SYMPHONY PARK LAS VEGAS, NEVADA

PC REVIEW

SDR-41033
REVISED

SDR-41033 - SITE DEVELOPMENT PLAN REVIEW - PUBLIC HEARING - APPLICANT/OWNER: SYMPHONY PARK MASTER ASSOCIATION, INC., ET AL - Request for a Site Development Plan Review FOR A PRIVATE PARK on 2.16 acres at the intersection of Symphony Park Avenue and Grand Central Parkway (APNs 139-33-511-009, 010, and 139-34-211-001), PD (Planned Development) Zone, Ward 5 (Barlow).

LANDSCAPE STUDY MODEL - SOUTH VIEW

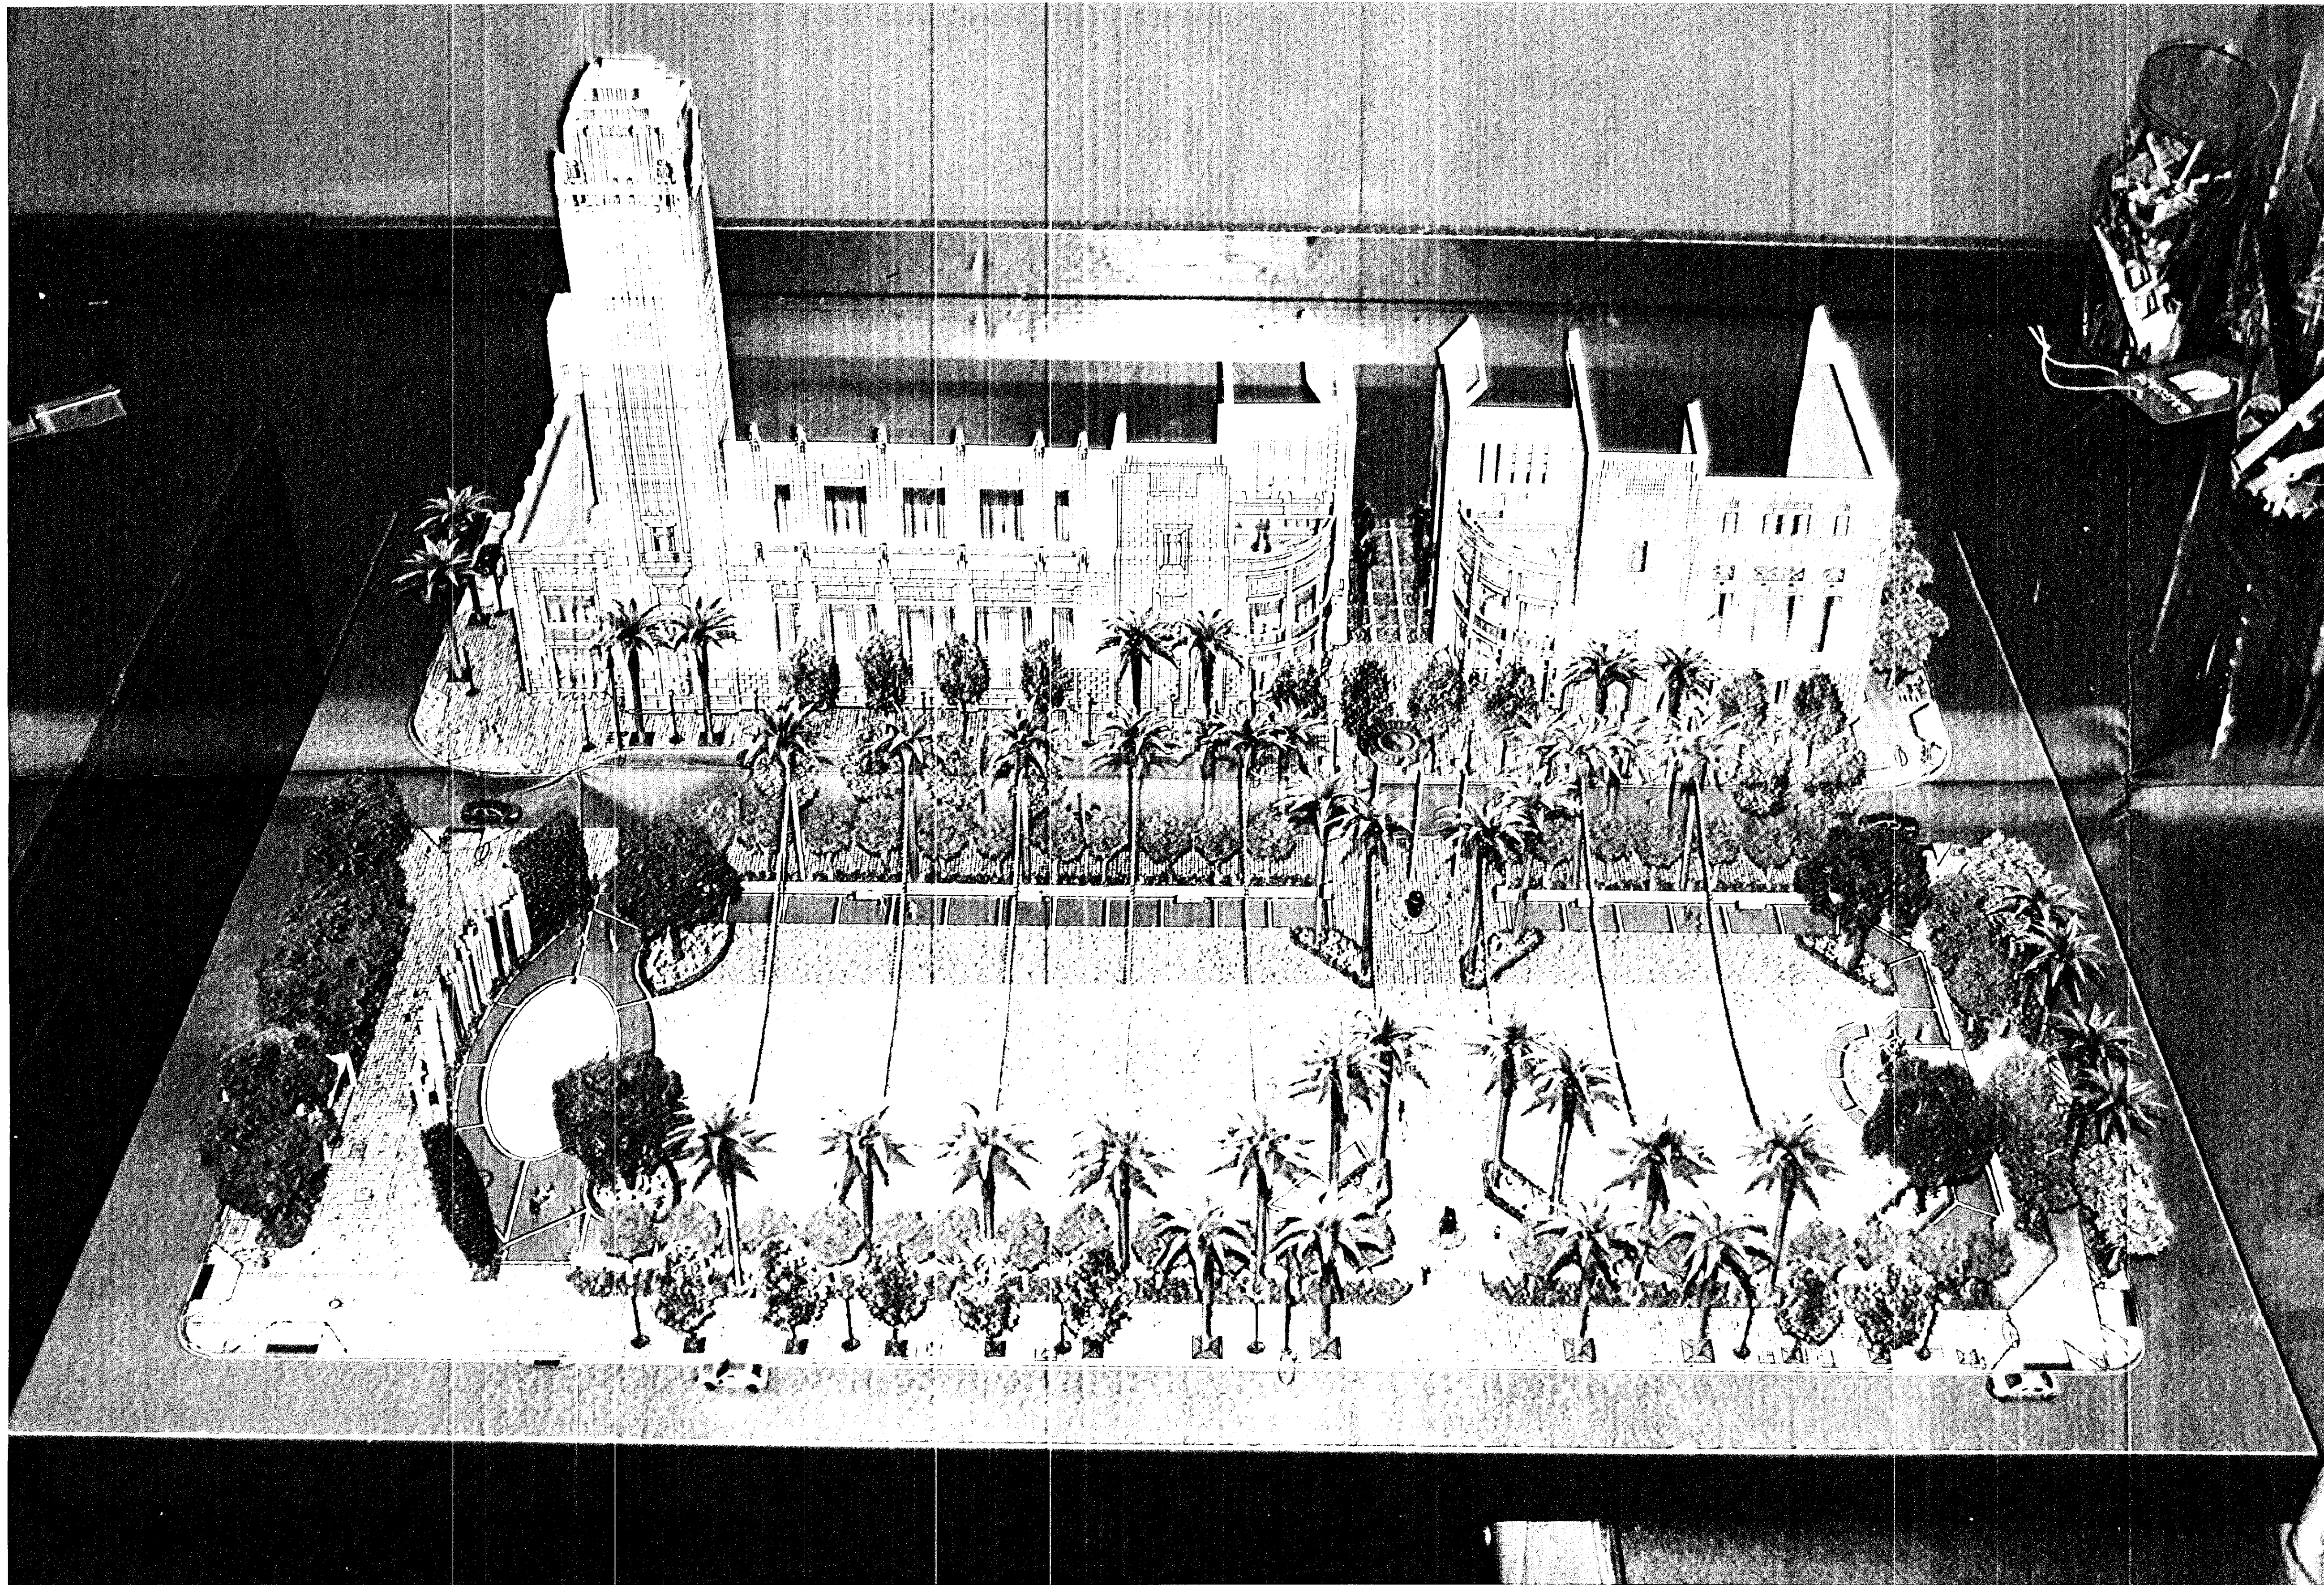
NOTE - STRING LIGHTS NOW TO BE ATTACHED TO POSTS (NOT PALMS) AS PER SPDRG REQUEST

DRAWING TITLE
LANDSCAPE
MODEL IMAGES
NORTH VIEW

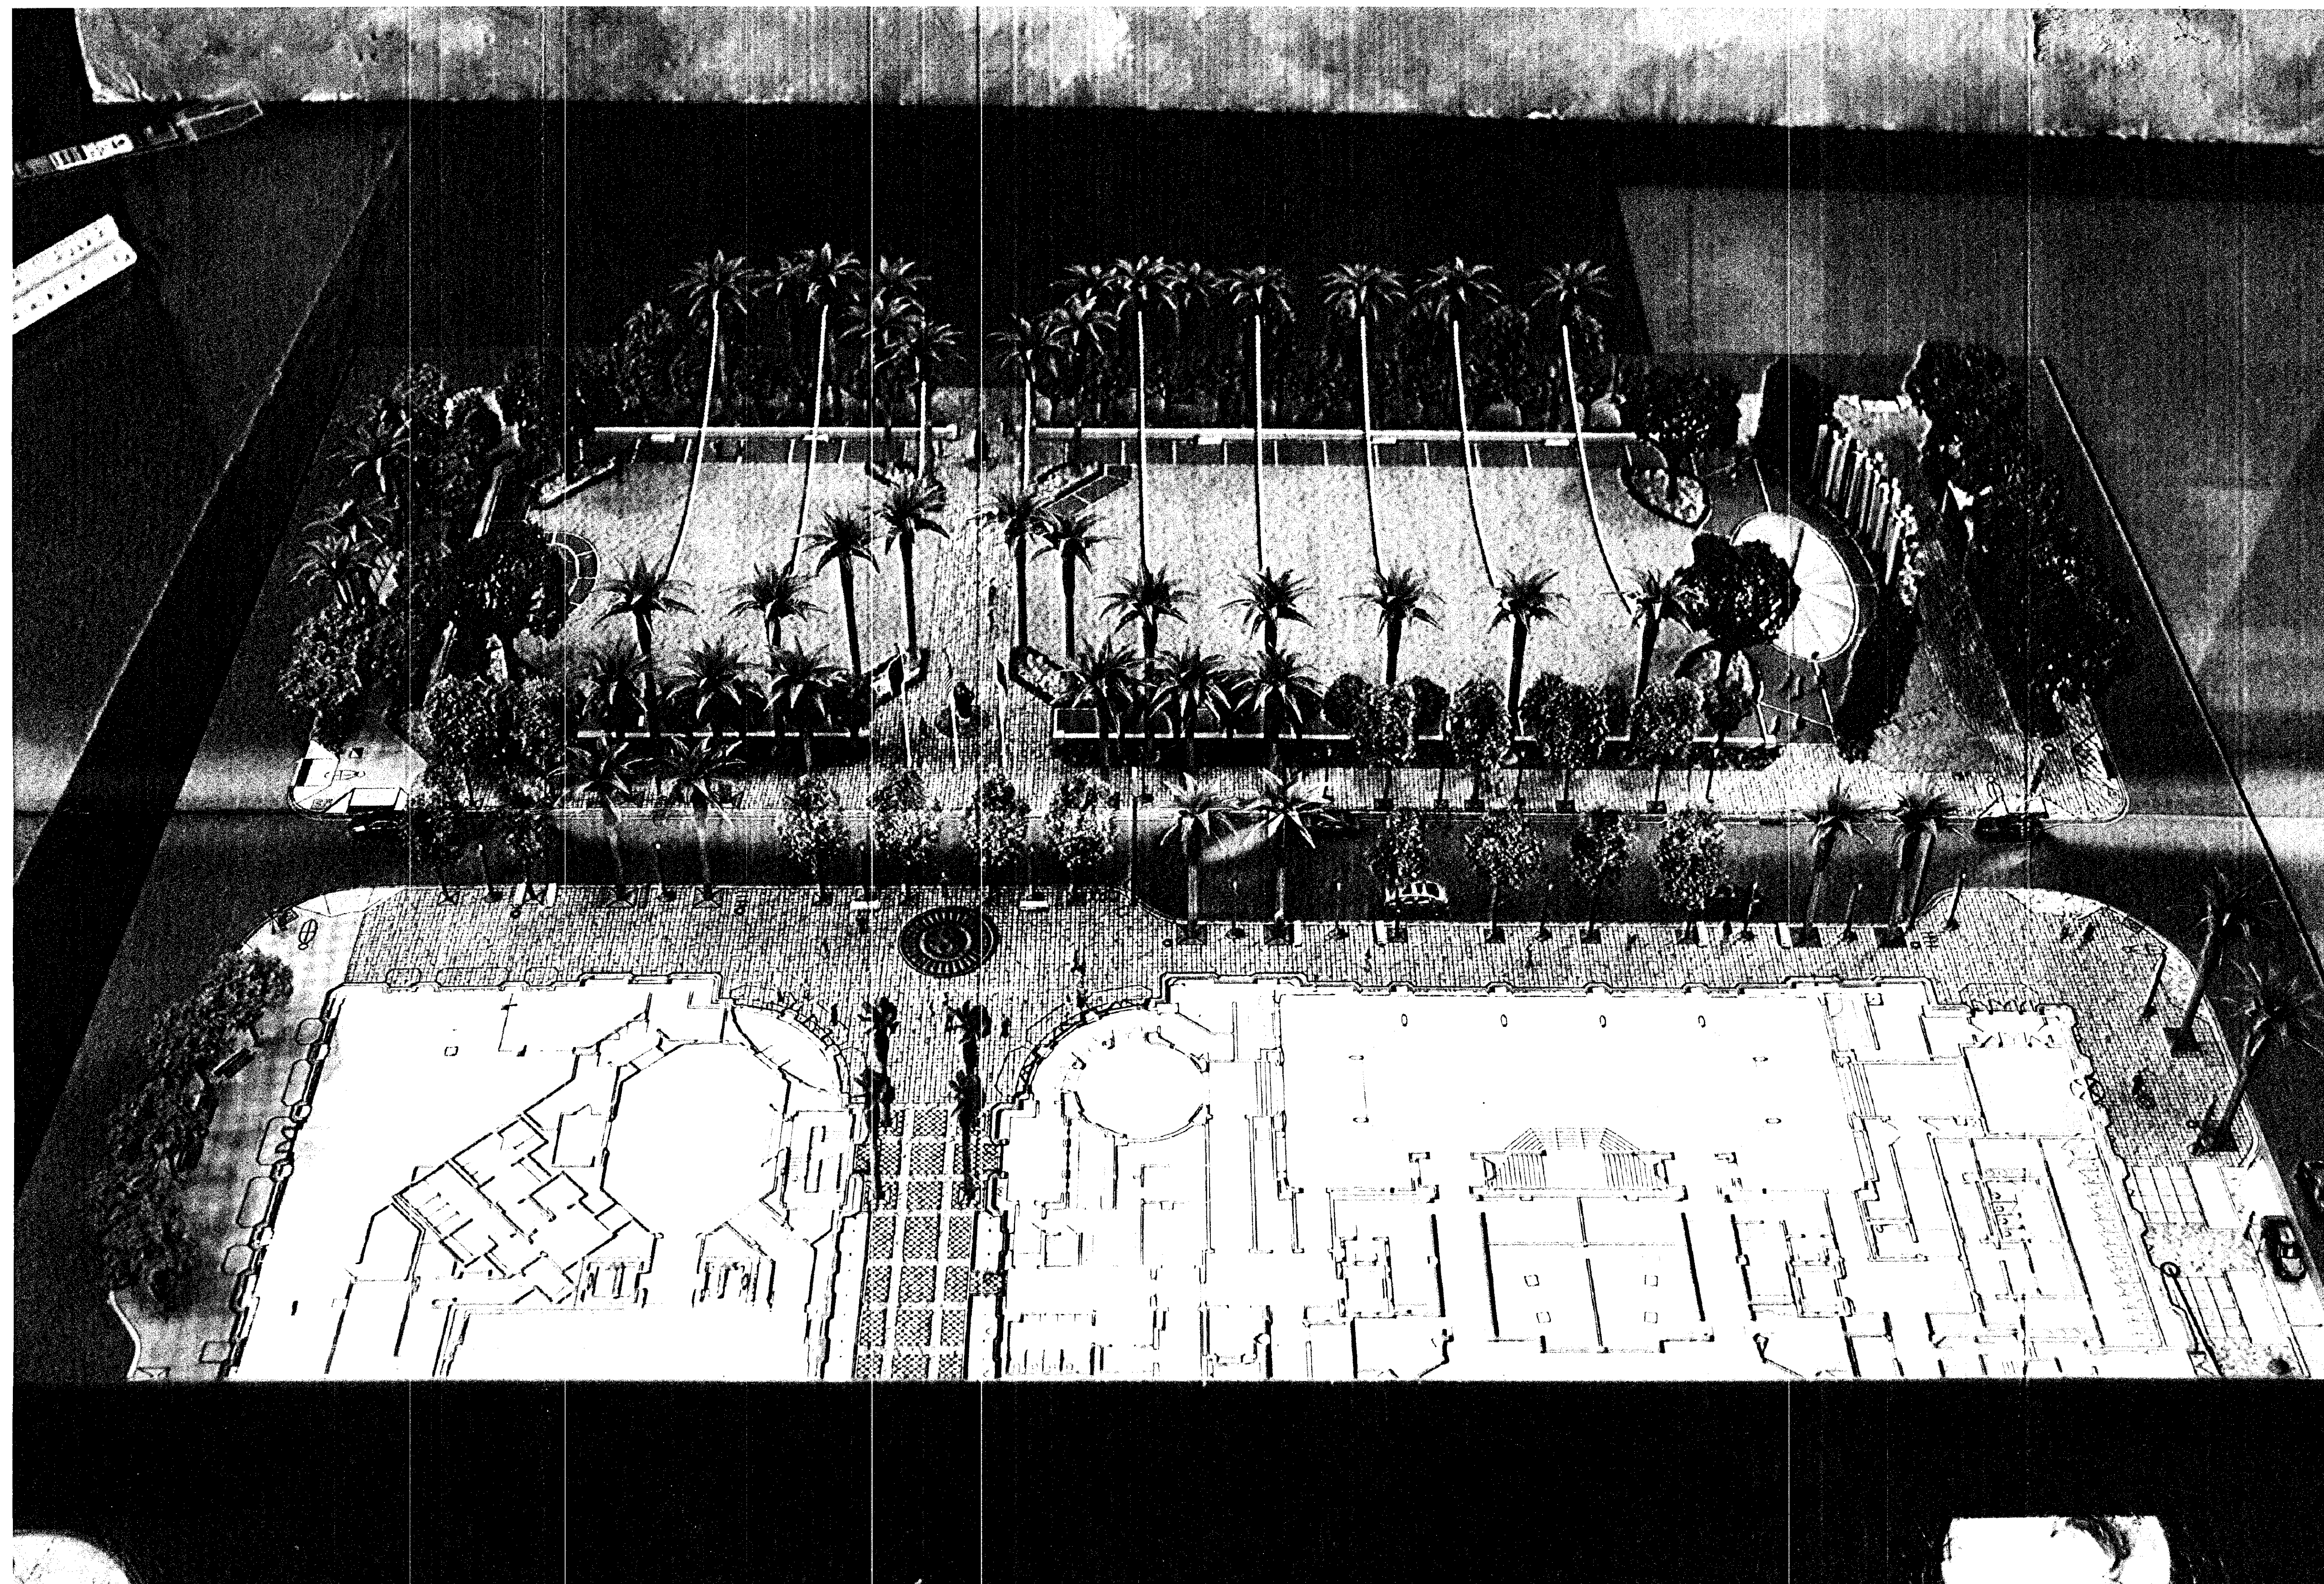
NOTE - STRING LIGHTS NOW TO BE ATTACHED TO POSTS (NOT PALMS) AS PER SPDRG REQUEST

DRAWING TITLE
**LANDSCAPE
MODEL IMAGES
SOUTH VIEW**

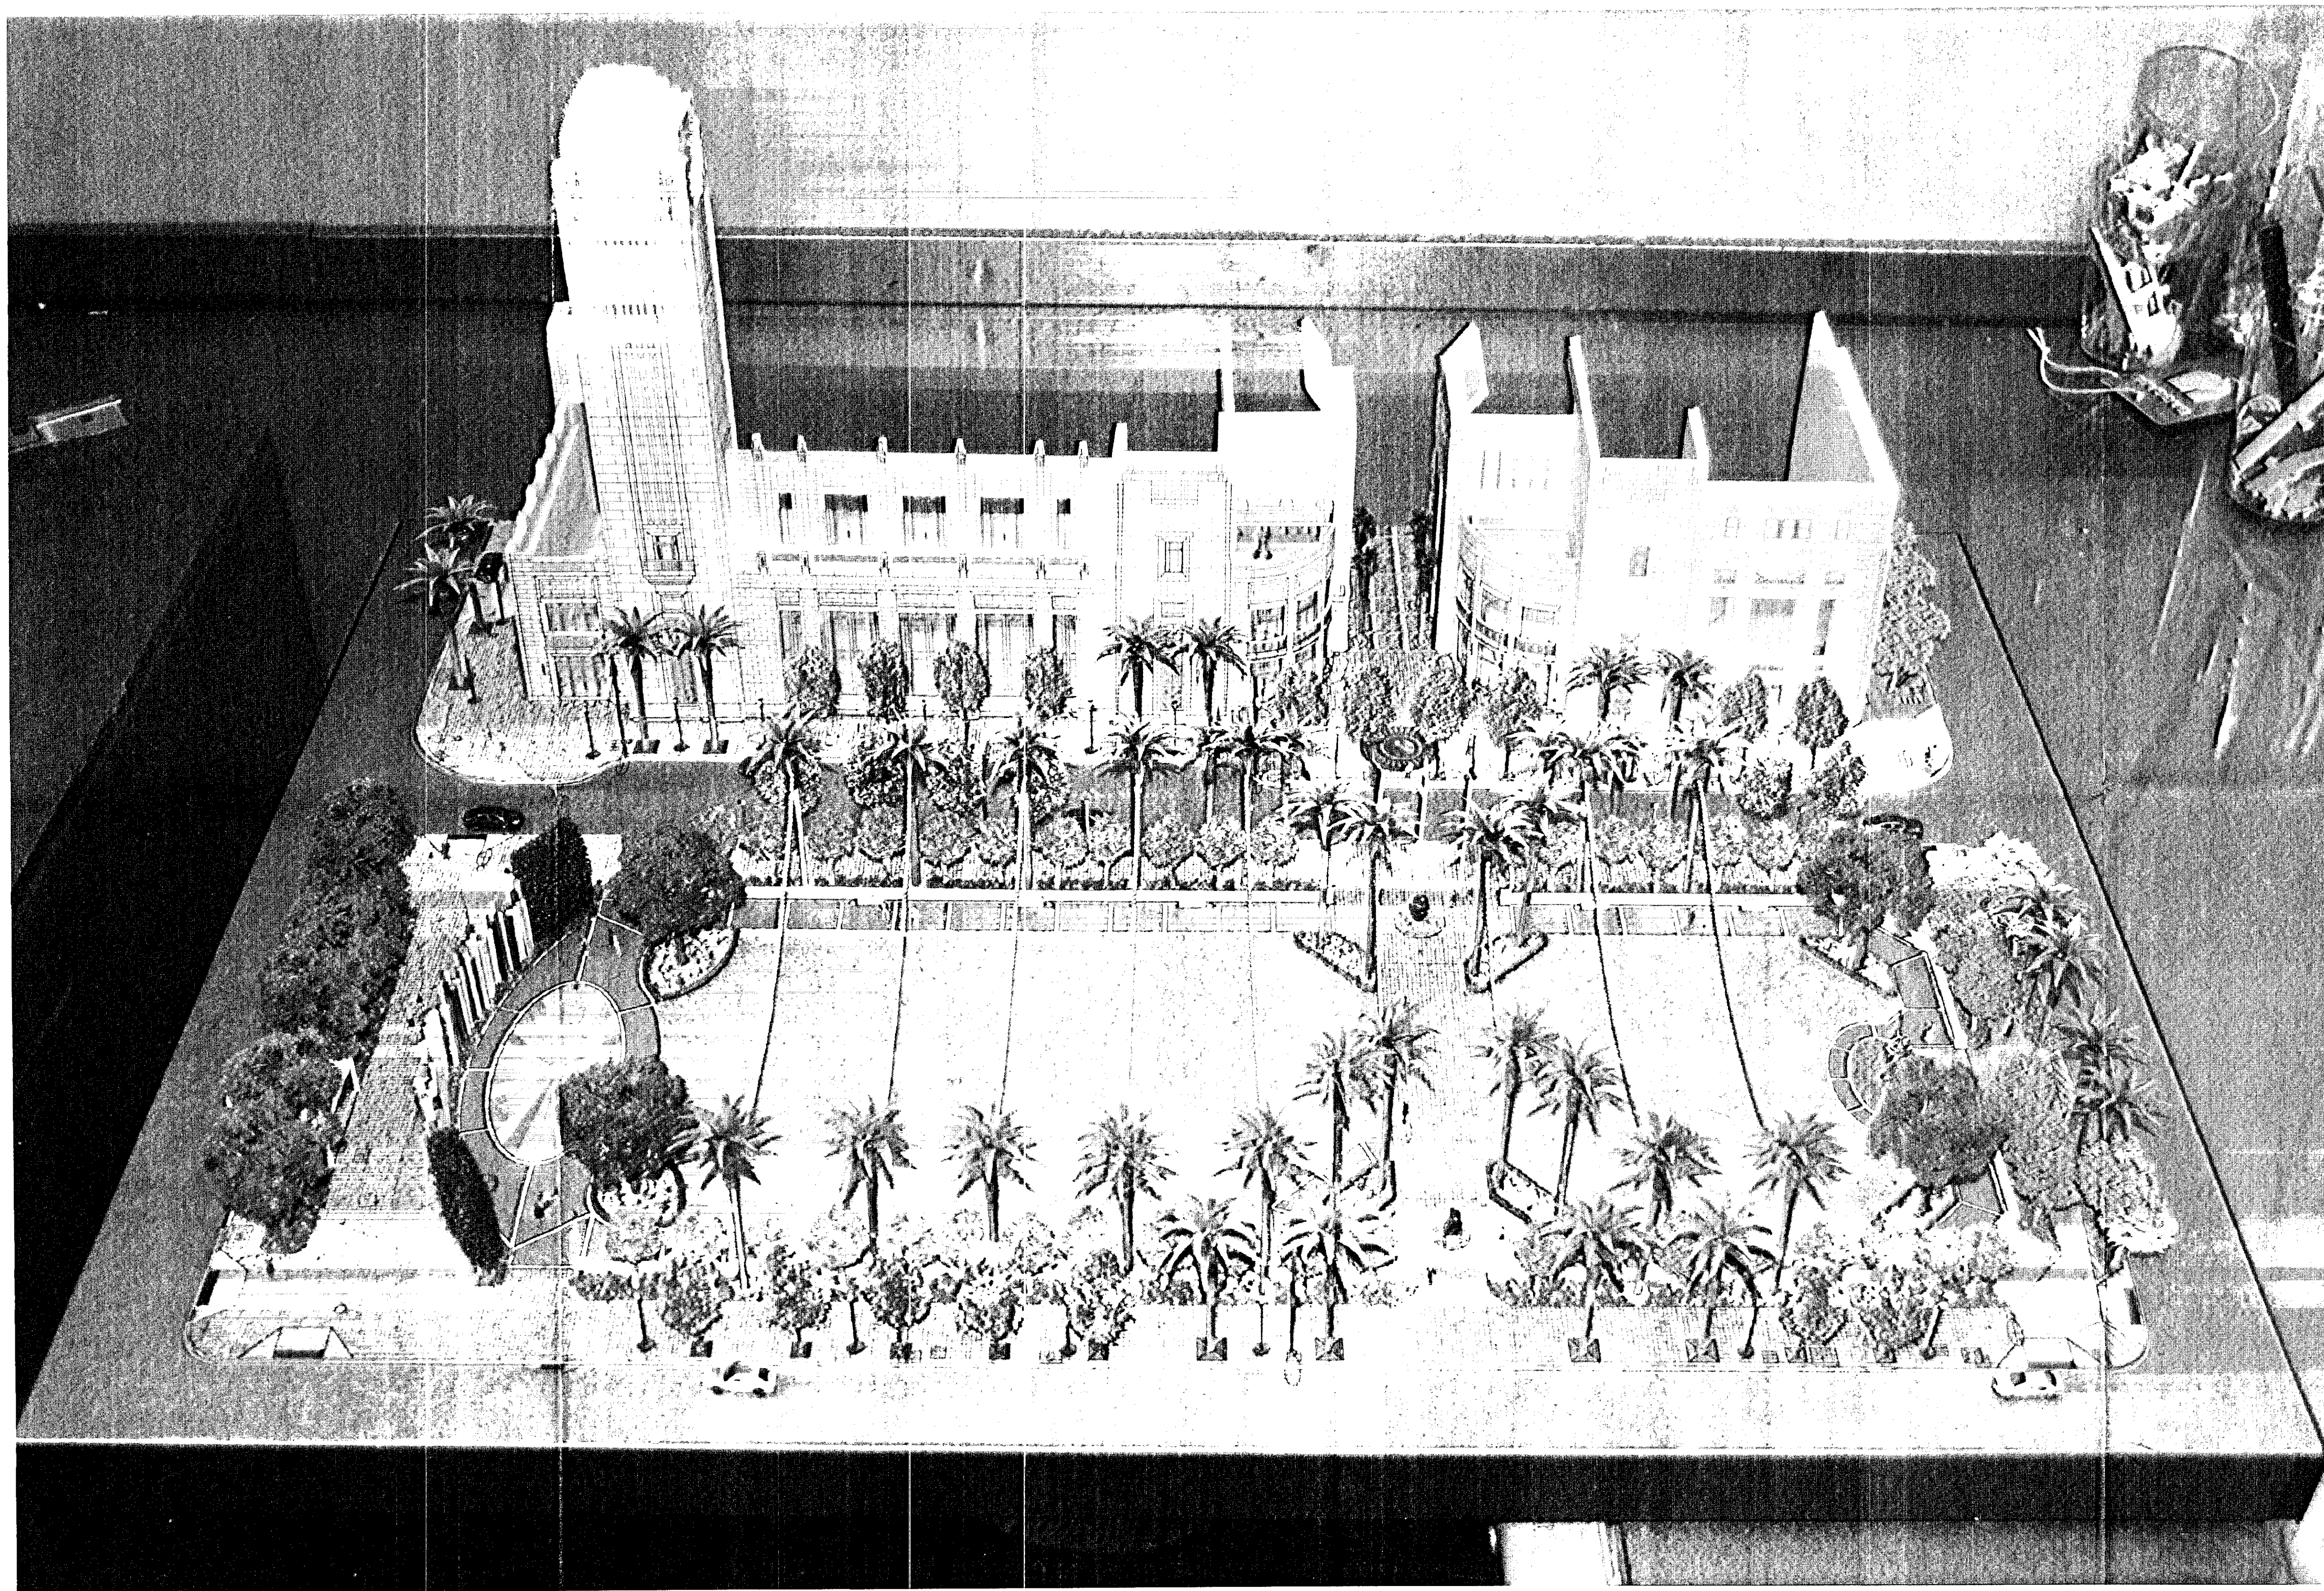
NOTE - STRING LIGHTS NOW TO BE ATTACHED TO POSTS (NOT PALMS) AS PER SPDRC REQUEST
